NASA Engineering and Safety Center Technical Report	Document #: RP-07-13	Version: 1.0
Title: Independent Review Support for Phoenix Mars Mission Robotic Arm Brush Motor Failure			Page #: 1 of 54

**Independent Review Support for Phoenix Mars Mission
Robotic Arm Brush Motor Failure**

March 8, 2007

Figure 6.1-1. Motor Brush Anomalies – Tip Failure (Left) and Pivot Failure (Right)

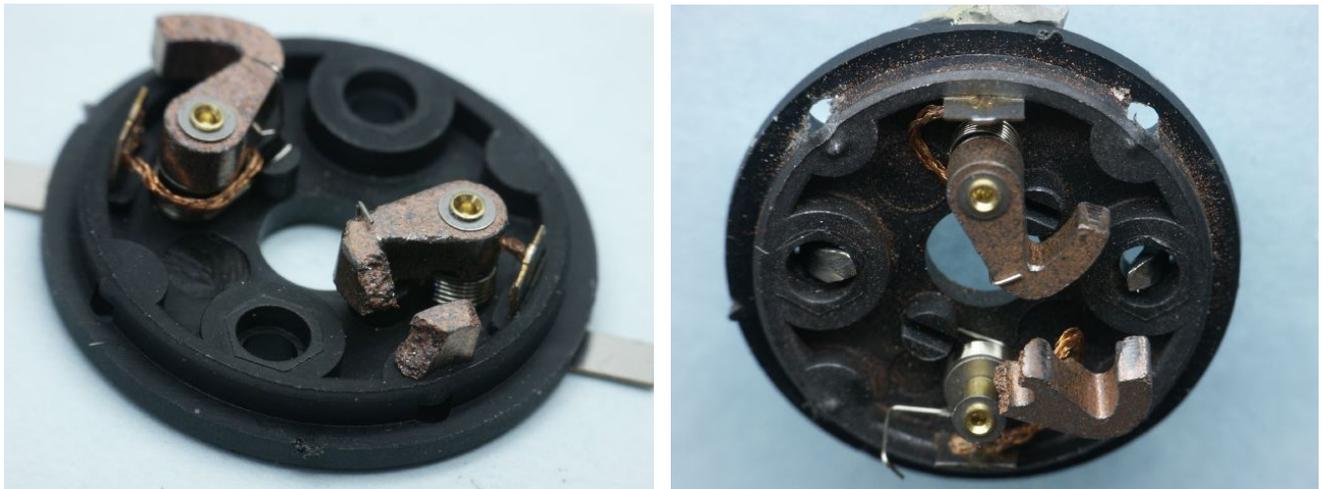
The anomalies with these motors occur in the commutating brushes. There are two failure modes that have been identified which are a concern for mission success (shown in Figure 6.1-1).

The risk events were broken into two parts, a root break and a tip break. As discussed in more detail within this report, a brush failure at the pivot (root break) is catastrophic to the motor, but there is a high likelihood that it will be detected through motor functional and system level testing.

A tip break is less likely to be detected during functional testing; however, a tip failure can still allow motor function but with a possible reduction in torque margin and/or life. There is some concern that a tip failure is an indication of brush strength on the low end of the data scatter; however, the strength of the weakest brush tested is still greater than 3x the predicted worst case qualification loads. Because of the motor functionality with a tip failure, the consequence is listed as a 4.

Figure 7.0-1. Image 6304 Motor N-Ray Image (Brushes Intentionally Not in Position)

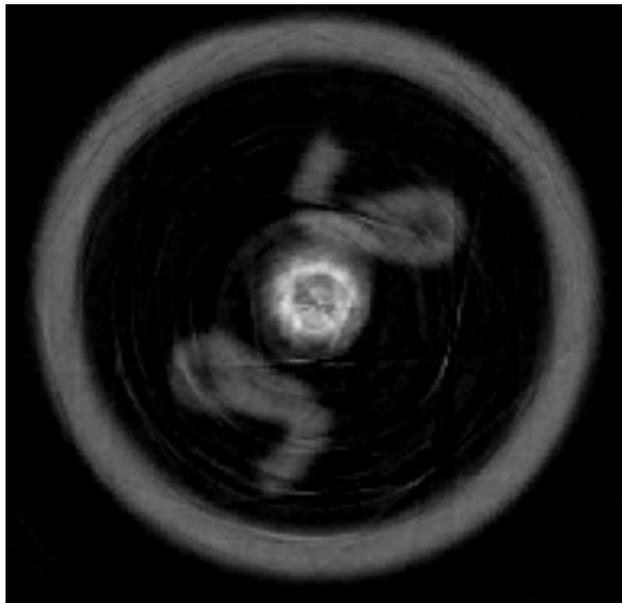
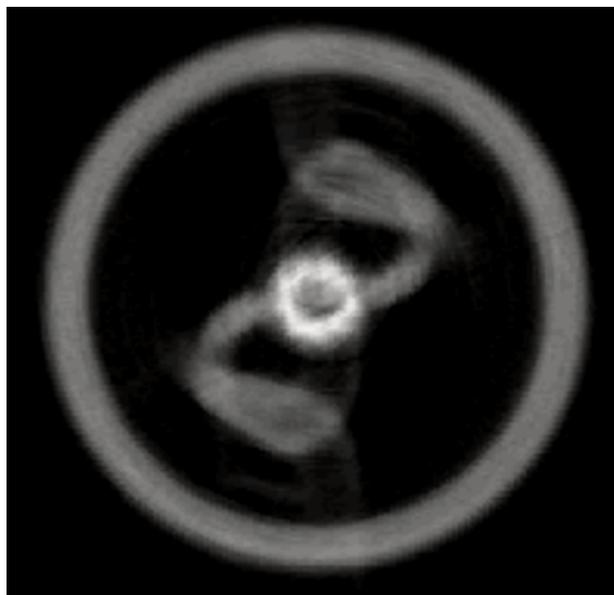
As Figures 7.0-1 and 7.0-2 shows, the graphite brushes are distinctive in both scans. When the images were magnified and slowly stepped through the sequential scans, some variation in the "density" of the brush was observed. This density variation however, is an artifact of the scan-and-reconstruction process. The use of N-ray beyond the detection of macroscopic breaks in the brushes would require an involved development effort to determine if flaws or pre-existing cracks could be detected.

1. N-ray imaging can distinguish the copper/graphite brushes within an assembled motor.
2. Gross workmanship errors and, potentially, macroscopic brush breakage can be detected by N-ray scan imaging without destructive disassembly of the motor.
3. N-ray scans should be able to detect a brush "tip break", or the brush "pivot break not displaced from the pivot".
4. N-ray should be able to penetrate any metallic overshield or housings around an integrated motor. However, it is currently not known whether Kapton™¹ tape overwrap or Kapton™ film heaters around a motor, integrated at the next level of assembly, would interfere with the imaging.

- F-3.** N-ray inspection can resolve macroscopic brush damage, but requires development to determine if cracking or other microscopic flaws can be reliably detected.

- R-1.** To reduce the risk for a LOM due to undetected motor brush degradation, the Phoenix Project should conduct a nondestructive inspection such as N-ray for evaluation of the RA DC motors as late in the assembly level as practical. However, once the RA has reached system level testing on the vehicle, removal of the motors for inspection is not recommended due to the potential for damage from the additional transportation and handling. (*F-1 and F-3*)

Figure 7.4-1. Brush Motor Armature/Commutator Design

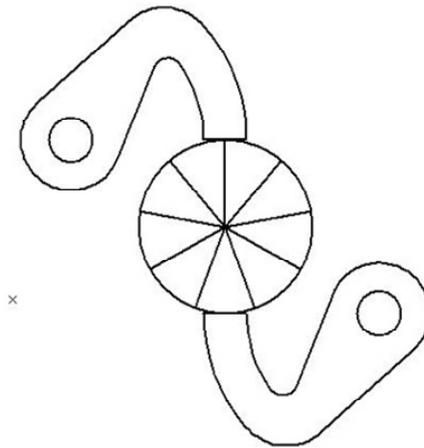
It appears that a brush break resulting from increased friction at the interface was deemed not possible because it is stated that this would only occur with metal brushes. This failure mode was observed in a different design brush motor used in an earlier project. The brush design was a cantilevered metal leaf with a platinum-silver brush. Unlubricated, insufficient life was exhibited. When lubricated with Braycote^{®2} grease, life was acceptable but, under cold

operation, one brush would fail in bucking because the adhesion of the brush to the commutator was greater than the buckling strength of the cantilevered beam.

All of the Phoenix Project motors are designed for bi-directional operation. Both brush bodies are in shear/tension in one direction of rotation and in shear/compression in the other direction of rotation (assuming non-zero sliding friction). The hooked “arm” of both brushes depicted in Figure 7.4-1 is bending at the “elbow” in either direction of rotation.

- F-6.** The bi-directional motor operation places complex reverse loading on the brush design which requires proper friction interaction with the commutator to minimize failure.
